**Plasma Spray Ceramic Coating NCSX Prototype Modular Coil
Shims**

NCSX-CSPEC-142-07-00

Revision 0

1. Single Hole Shim SE140-199-8

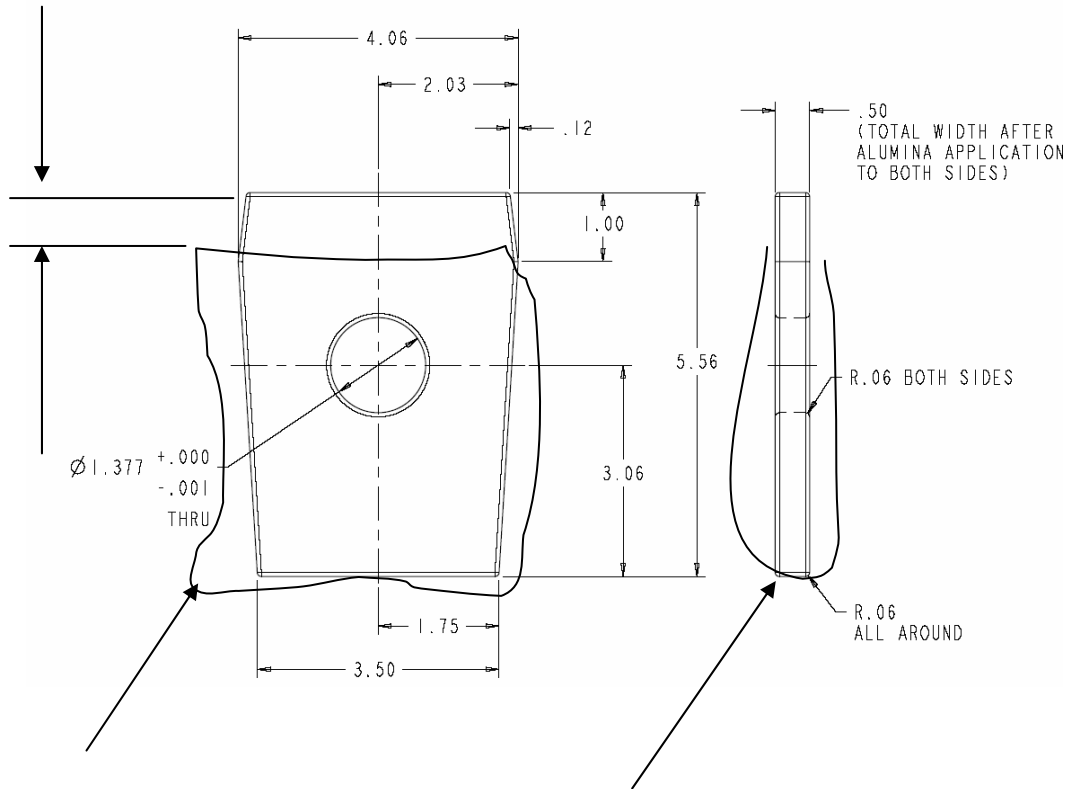
.5" handling area

Coat large flat surfaces

Coat narrow edges and radii
